**INVITATION FOR BID IFB-PAG-026-002
 SUPPLY, REMOVAL AND REPLACEMENT OF 1500KVA, 3-PHASE, OIL-FILLED
 TRANSFORMER AT THE LC-4 PROJECT.**

ADDENDUM NO. 2

Supply, Remove and Replacement of the Existing 1500kVA, 3-Phase, Oil Filled Transformer at the LC4 Project
IFB No.: PAG-CIP-026-002

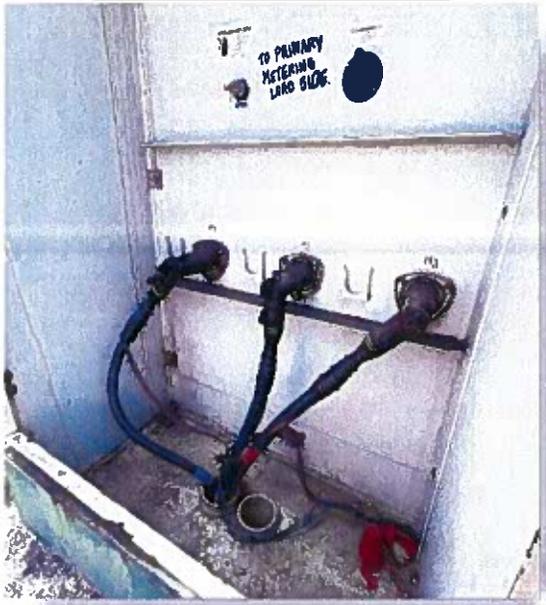
1. There are two transformers in this project. Please confirm whether the American box transformer is made of copper or aluminum, the ring network type or the terminal type. Are there any requirements for efficiency?

- All transformer shall be copper /copper as stated in SOW #8 page 4.
- Terminal type 6 holes spade. See attached photo for reference
- Efficiency 99% at 50%load

Secondary side connection – six holes spade type terminal

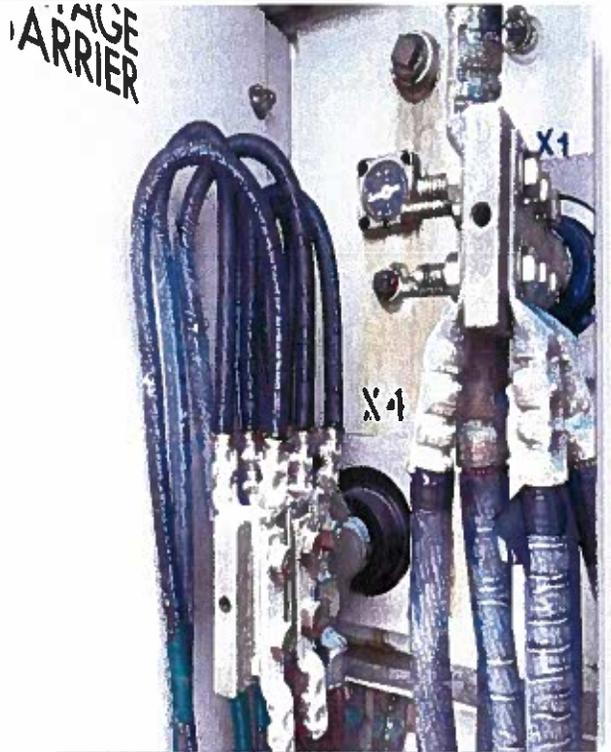
- Tap range?
YES, for primary, see attached photos
- Cooling type?
See SOW page 4. Envirottemp FR3 fluid or ONAN (Oil Natural Air Natural)
- Tap changer type: off-circuit tap changer or on-load tap changer?
See SOW page 11, match the existing. OFF circuit tap changer. See photo attached

- Equipment's included: tap changer, thermostat, temperature sensor, pressure relief device, oil level gauge, etc.?
YES, See SOW page 5 #19
- Type of HV/LV bushings and cable entry method?
Match the existing transformer (see SOW pages 9&10). Bushing boots for HV. Spade terminal, 6 holes for LV. Bottom feed method for cable entry. See photo attached.

Primary side connection

Secondary side connection

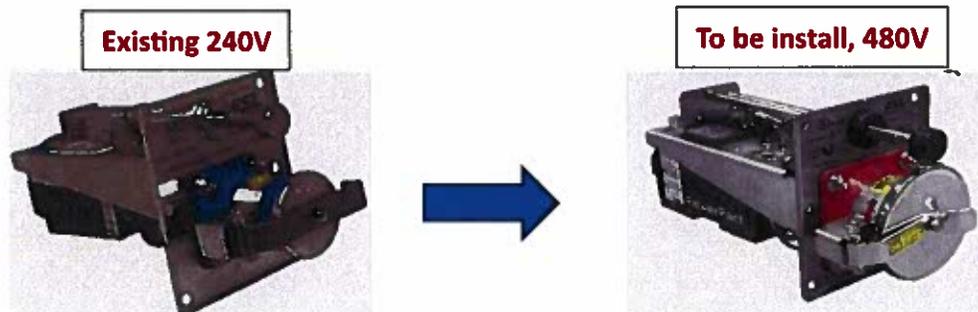
3. Please confirm that the supply of matching plugs for Reefer receptacles is the contractor's responsibility, and the supply and installation of the industrial extension cord is the responsibility of the Port Authority of Guam.

Please check SOW pages 7 & 14. Contractor will replace ONLY the internal parts. Reefer outlet frame and extension cord are to remain. Remove the existing 240V reefer outlet (internal only as shown below photo) and replace with 480V reefer outlet using the same frame. The 240V and 480V reefer outlets are the same frame dimension.

See below one line diagram with new transformer showing where we can connect:

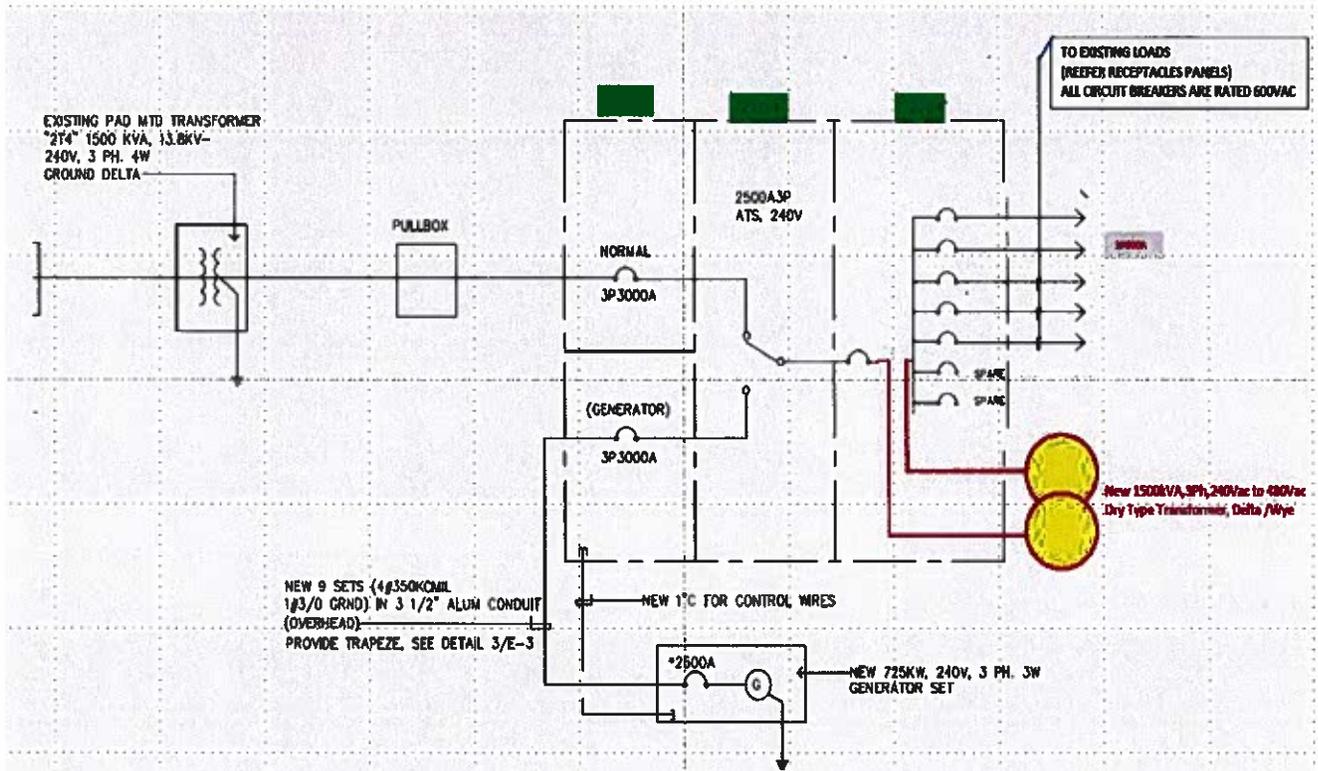
5. Please provide the LC-4 as-built electrical plans, showing a detailed one-line diagram and layout, including the details of the existing switchboard.

- 1.) Please see SOW page 13. PAG is willing to accommodate you, if you need another walk-through inspection on the field particularly at LC4, so you can visualize the detail of the existing switchboard and one line diagram.

All circuit breakers are rated 600Vac.
